Docket Number:	03-AFC-01C
Project Title:	Roseville Energy Park Compliance
TN #:	220856
Document Title:	Notice of Determination -- Petition to Amend - Roseville Energy Park
Description:	Staff has determined the project would continue to comply with applicable LORS and no changes to any conditions of certification are necessary to ensure that no significant impacts occur
Filer:	Mike Monasmith
Organization:	California Energy Commission
Submitter Role:	Commission Staff
Submission Date:	8/22/2017 4:50:24 PM
Docketed Date:	8/22/2017

**NOTICE OF DETERMINATION
PETITION TO AMEND
ROSEVILLE ENERGY PARK, 03-AFC-01C**

ENVIRONMENTAL JUSTICE FIGURE 1
Roseville Energy Park - Census 2010 Minority Population by Census Block

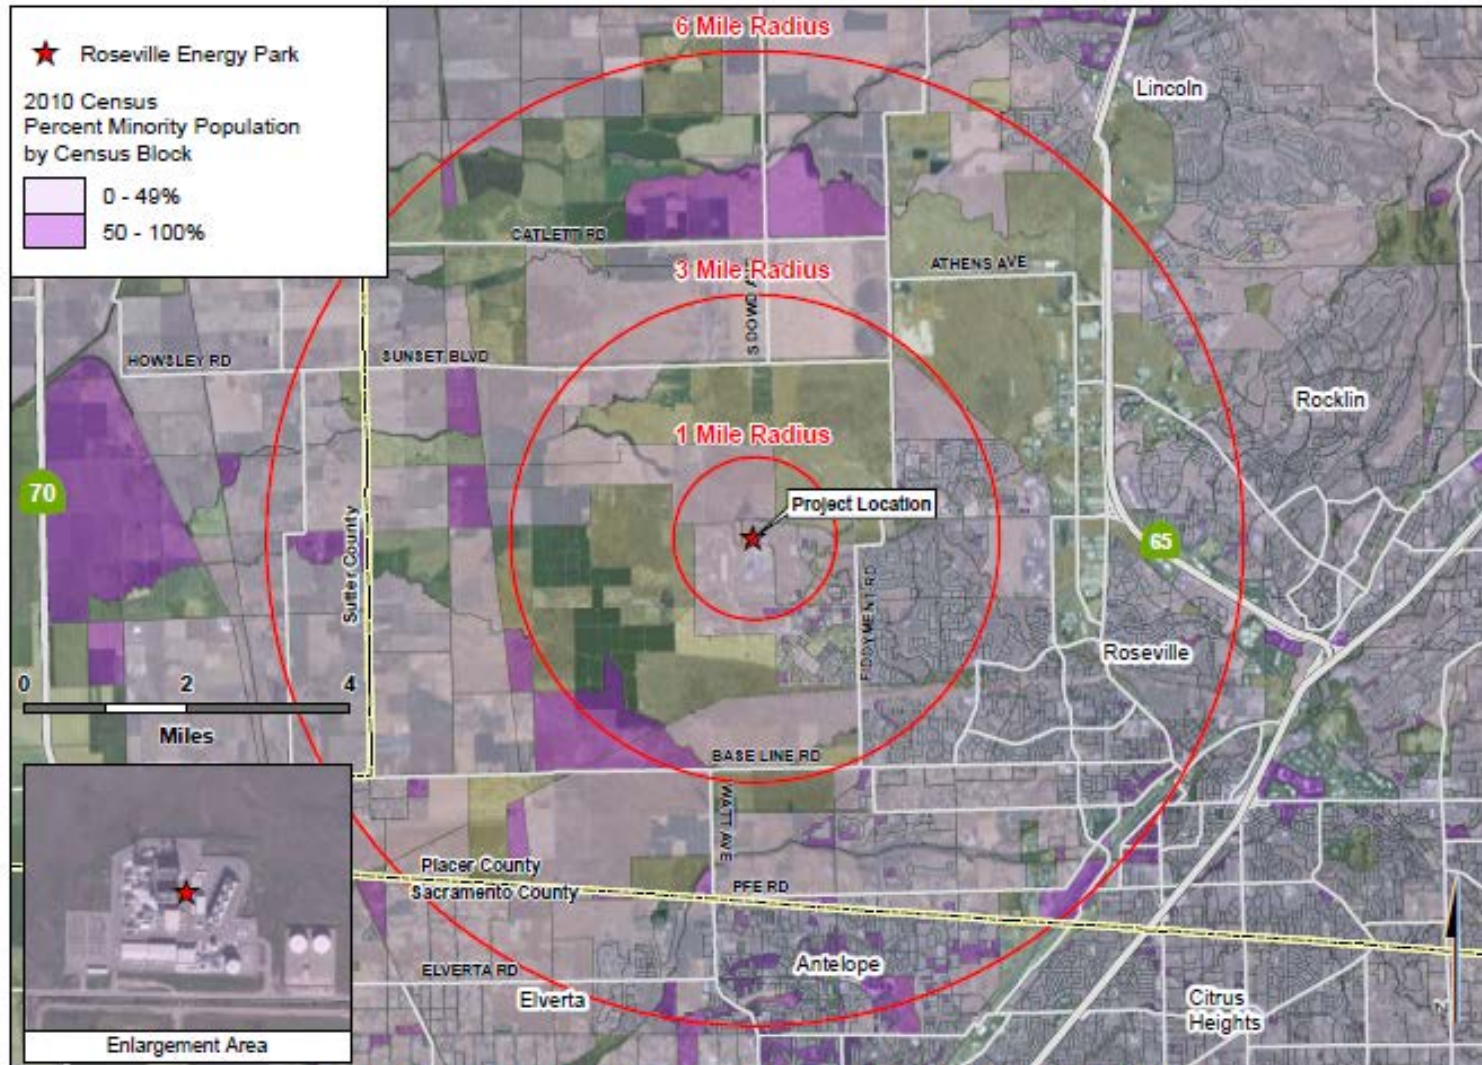
The **Environmental Justice Population Figure 1** (attached) shows 2010 census blocks in the six-mile radius of the REP with a minority population greater than or equal to 50 percent. The population in these census blocks represents an Environmental Justice (EJ) population based on race and ethnicity as defined in the Council on Environmental Quality's *Environmental Justice: Guidance Under the National Environmental Policy Act*. Staff has determined that the proposed modifications would not cause any significant environmental impacts, including the environmental justice population. Therefore, there are not significant

impacts to any population within the REP six-mile radius, including environmental justice population.
